com_ieee8023_93a_161 revision document

Richard Mellitz

Intel Corporation

11-02-2015

Added parameters and outputs

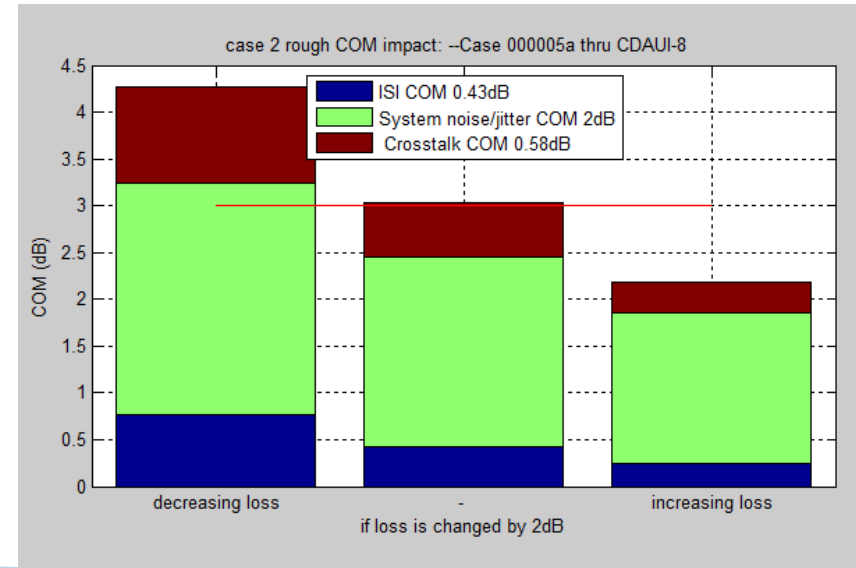
- Support for later Matlab 2015
- added output parameters
 - `peak_uneq_pulse_mV` – peak value of the unequalized SBR
 - `cable_loss` when "Include PCB" is not 0 in the config file
- added: tap `c(-2)` `c(2)` and `c(3)`
 - new value for "Include PCB" = 2 for cable Rx compliance test, Only the Rx host boards is added.
- Added
 - New keyword `BREAD_CRUMBS` if 1 then a mat file with the structures "params" and "OP" is created in the results directory
 - New keyword `COM_CONTRIUBTION`
 - When set to 1 a rough approximation of COM contributions chart replaces the bathtub curves
 - When set to 0 the bathtub curves are displayed

For RITT testing (potentially for IEEE802.3by)

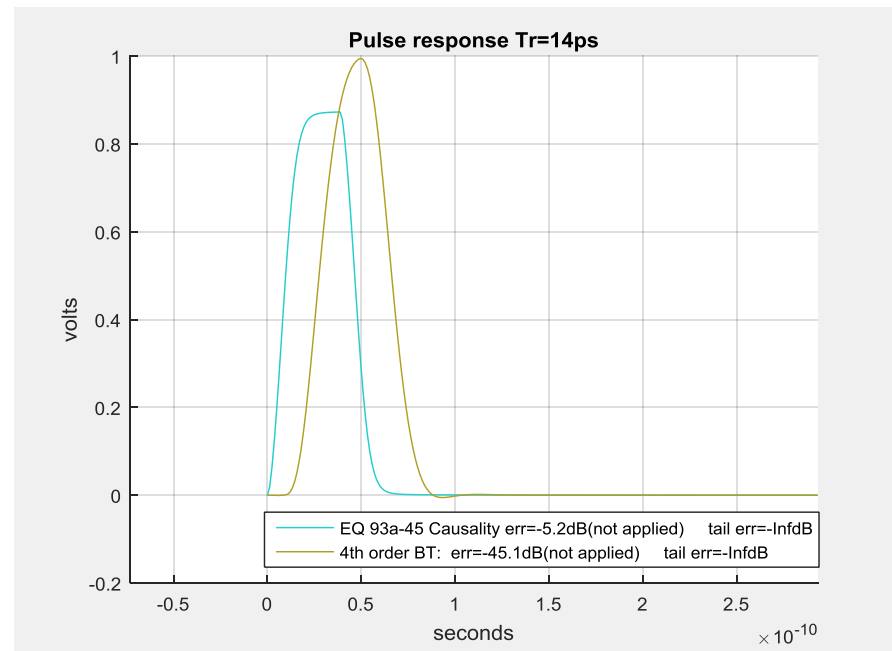
- added:
 - Keyword `T_r_filter_type`
 - for RITT testing when `IDEAL_TX_TERM` is 1
 - For use with test equipment pattern generator
 - Keyword `T_r_meas_point`
 - 0 is @ tp0a
 - 1 is @ PGC or tp0
- 0 is for is for Gaussian filter (eq 93a-46)
- 1 is for a 4th order Bessel-Thompson filter
 - Fix for causality
 - $$H_t(f) = \frac{105}{(f^4(k*T_r)^4 - 10j*f^3(k*T_r)^3 - 45*f^2(k*T_r)^2 + 105j*(k*T_r) + 105)}$$
 - where $k=8.87$
 - If measurement is at tp0a
 - $k=(5.475e-6/(T_r)^{(1.282)} + 1.024)*k$
 - To account for test fixture loss
